**MEMORANDUM**

**FROM:** Andy Crossland - Geologist  
ERRD/PSB/TST

**SUBJECT:** Review of the *MW-19/Hot Spot 1 Area Remedial Investigation Report*, L.E. Carpenter, Wharton, New Jersey.

FIGURE 6

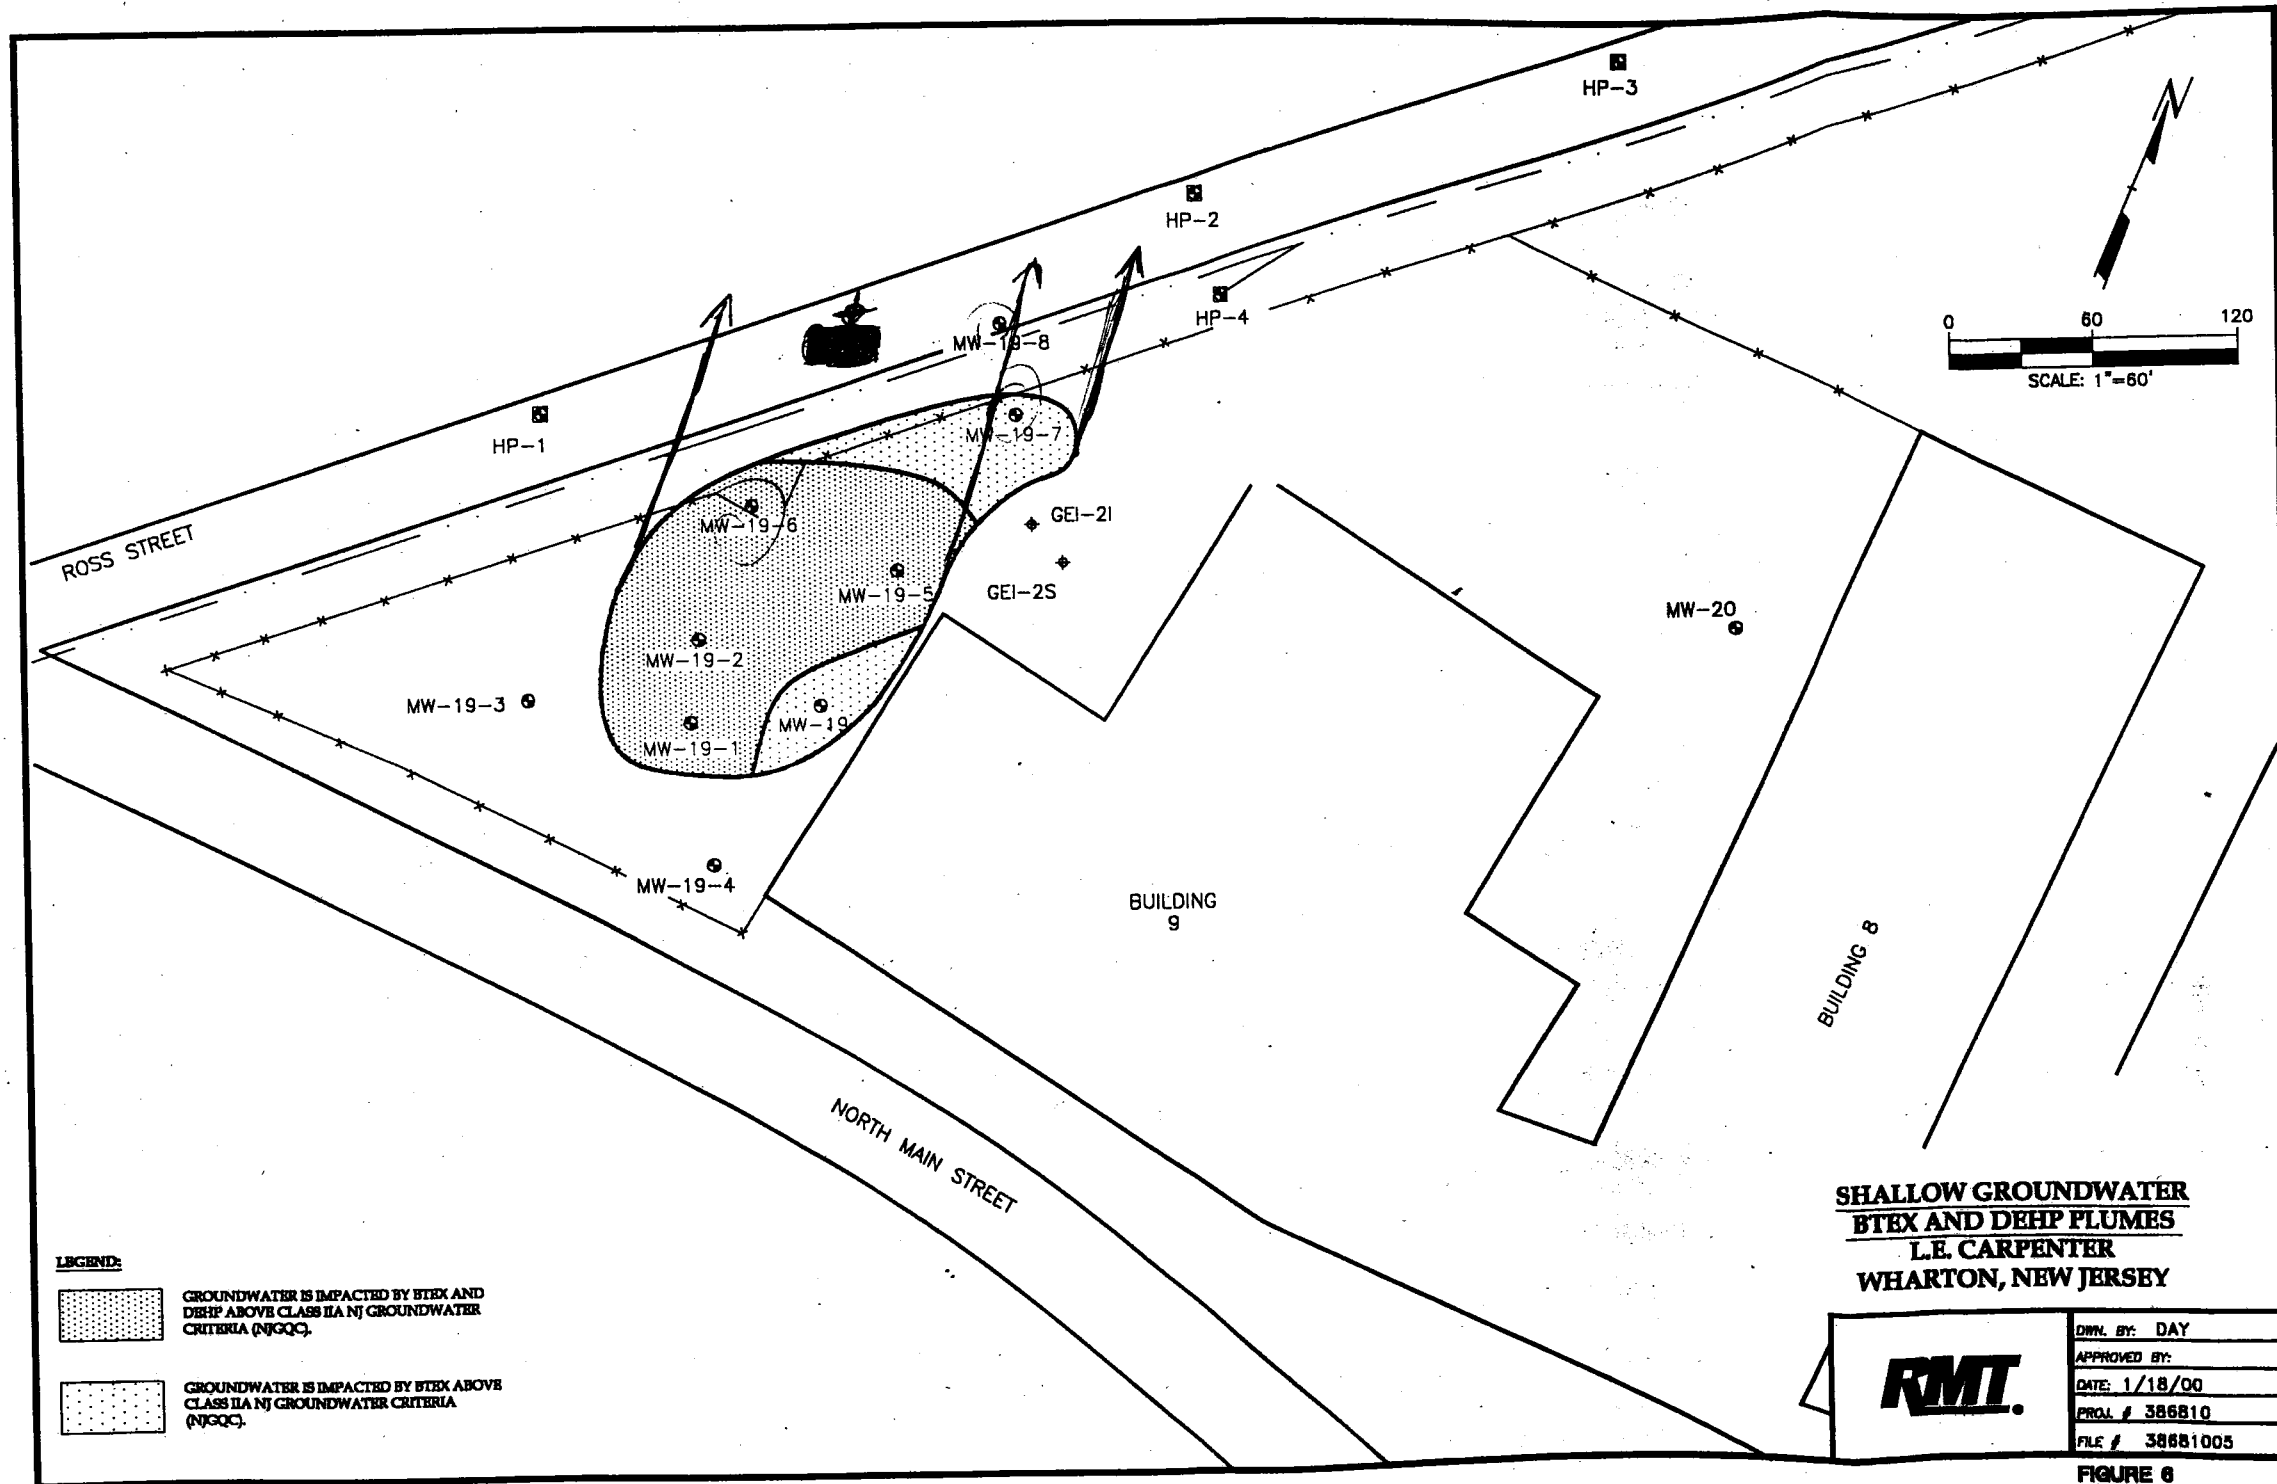
The report concludes that the extent of groundwater contamination has been fully delineated. However, there delineation is weak in two respects. Well MW-19-6 has been shown to contain levels of toluene and DEHP which are above the NJ groundwater criteria. No wells are present downgradient of this point and therefore the extent of contaminant migration is incompletely defined. In addition, and as has been discussed, the vertical extent of contamination has not been investigated. The possible downward migration of contaminants needs to be addressed by a deeper well downgradient of the hottest area.

As a result of the above issues, it seems appropriate to drill a two well cluster on the north side of Ross Street. The attached figure shows the optimal location. The shallow well would be screened across the water table, as other wells in the area (likely with a total depth of 20 ft bgs). The deeper well could then be emplaced with the top of its screen 5 ft below the bottom of shallow well (with a screened interval from 35-25 ft bgs). Although this leaves a 5 foot gap in the vertical profile, it allows for a slightly deeper interval to be monitored.
